## STAFF REPORT FOR THE PLANNING COMMISSION

**FILE NUMBER:** PUD-14-01/DR-14-01/WAP-14-01

**REQUEST:** 26-unit duplex development on common lot, requesting Class II Design Review approval, Water Resource Area approval (no development proposed in WRA), and Planned Unit Development (PUD) approval with a density bonus at 18270-18340 Willamette Drive and 18395 Shady Hollow Way.

The application is for a 26-unit development consisting of 13 duplex buildings. This is a Planned Unit Development (PUD) on three existing parcels at the intersection of Willamette Drive (Highway 43) and Shady Hollow Way in the Robinwood neighborhood.

SHEET TITLE  
PROPOSED SITE  
PLAN / ANALYSIS

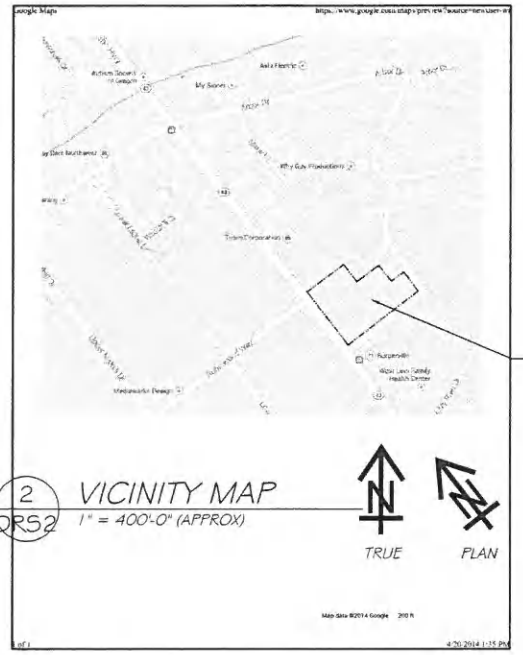
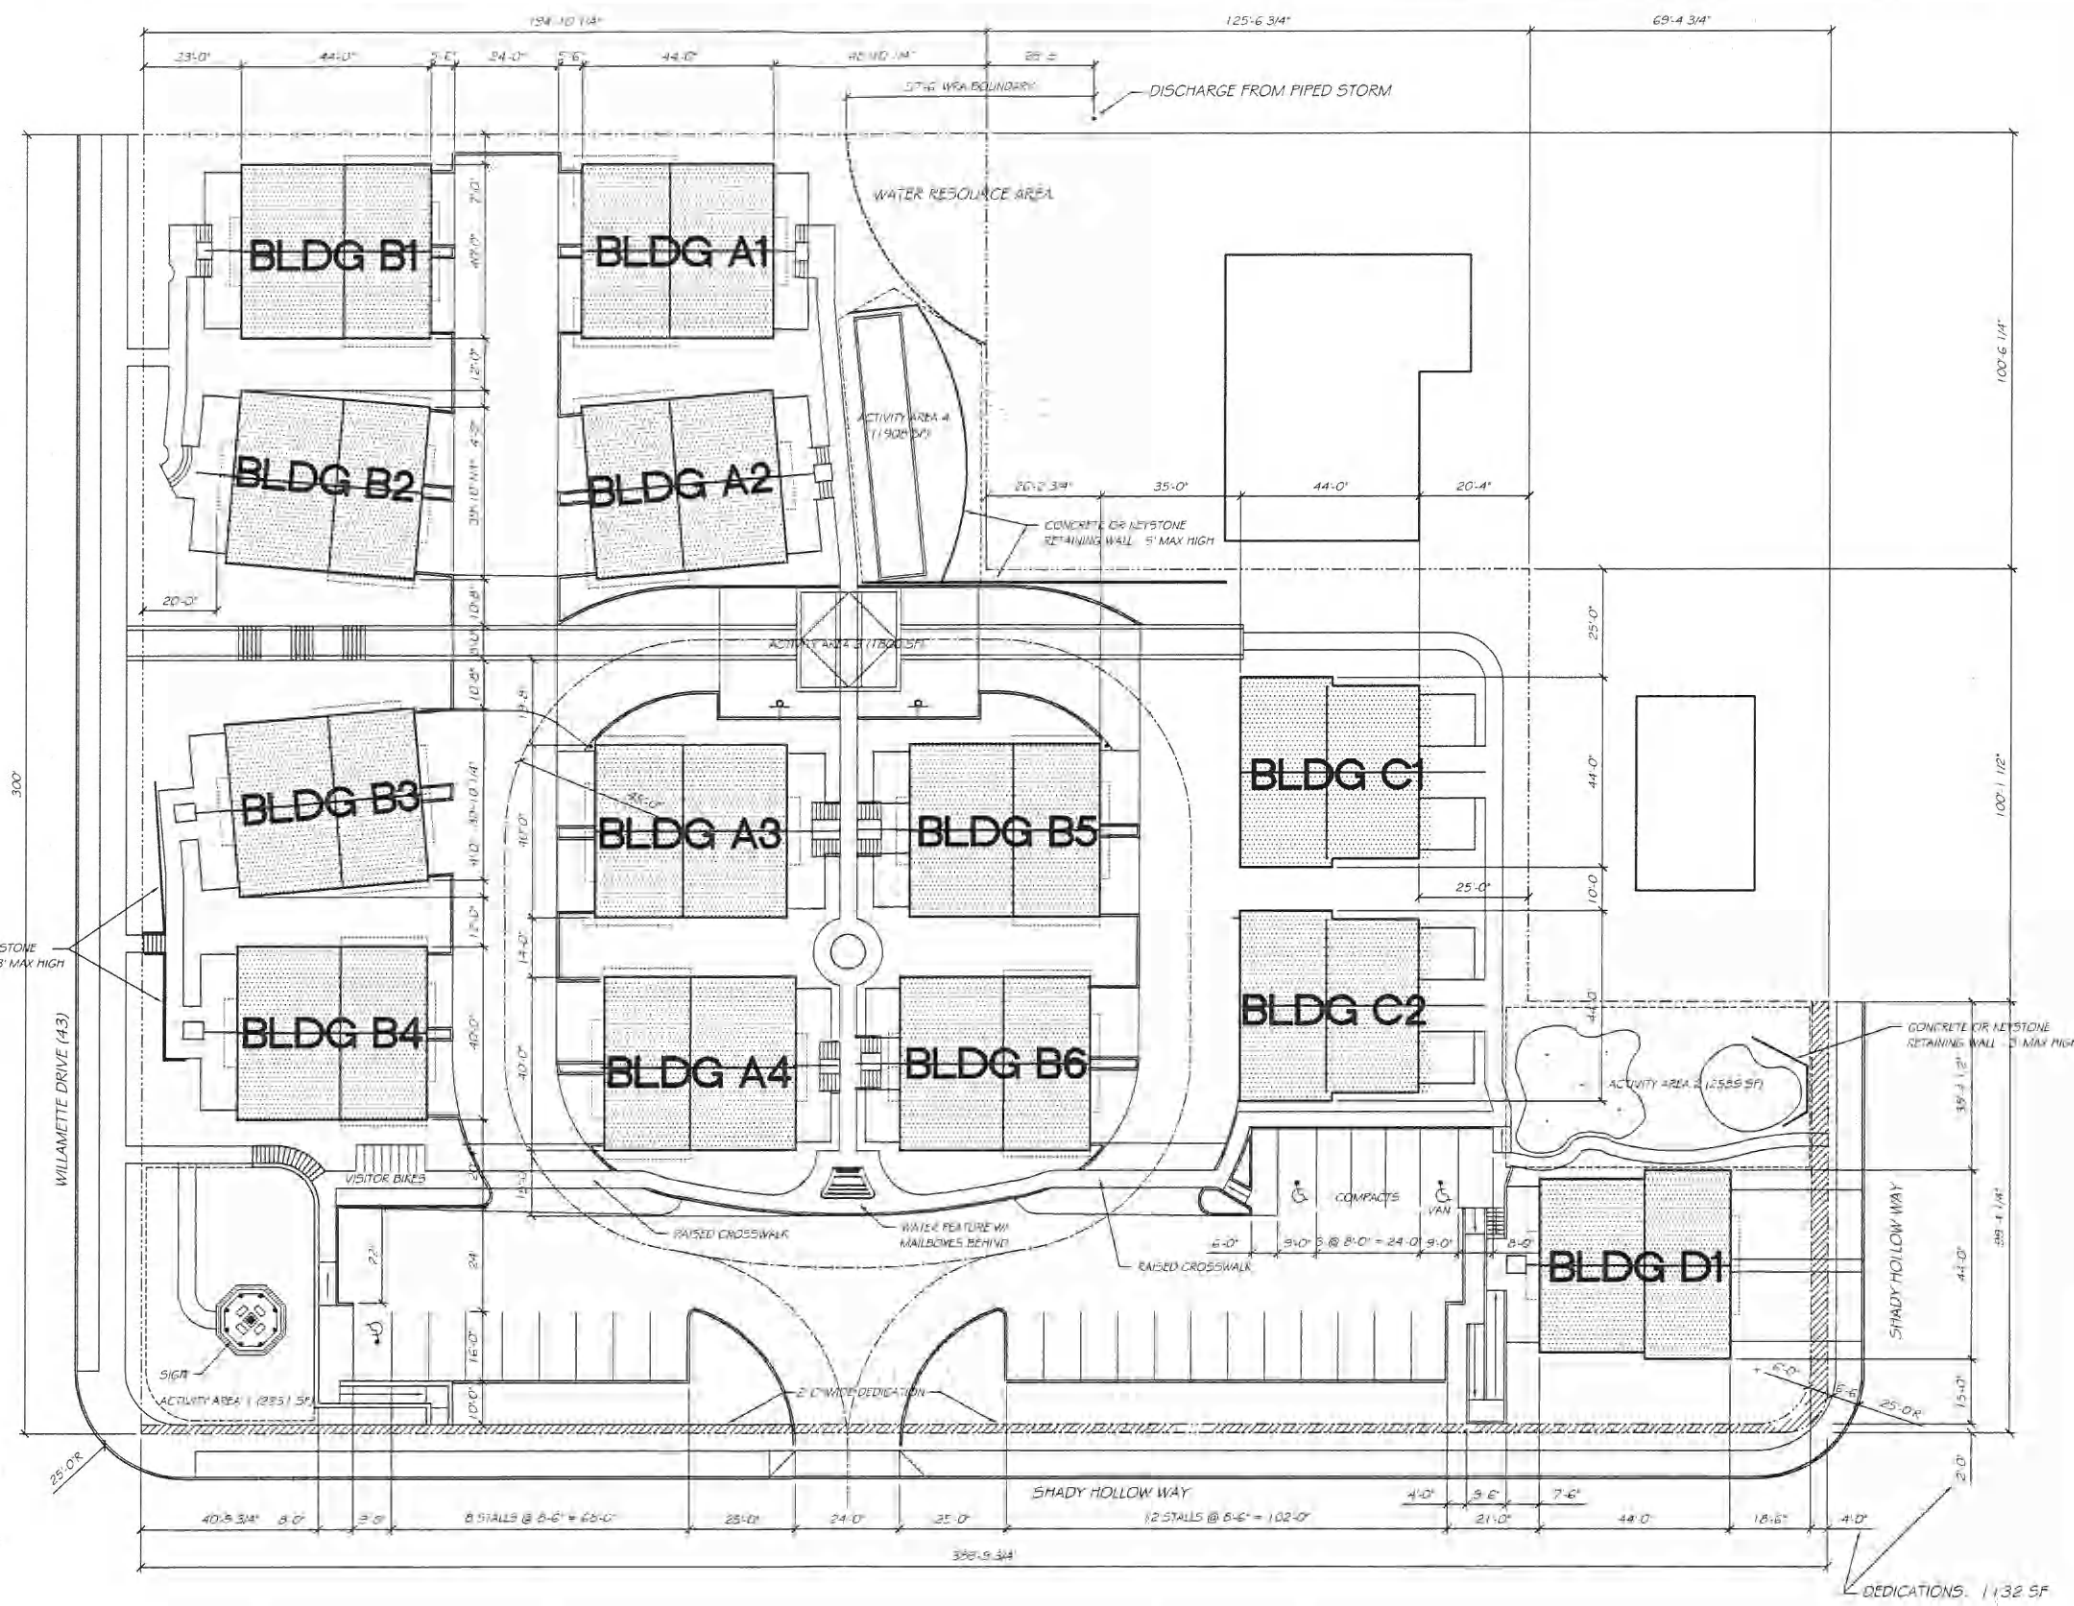
**Staff Response 17:** As shown on Sheet DRS2 Proposed Site Plan/Analysis on Page 85 of Exhibit PC-6, the proposal meets all of the above setback requirements if this is a common lot.
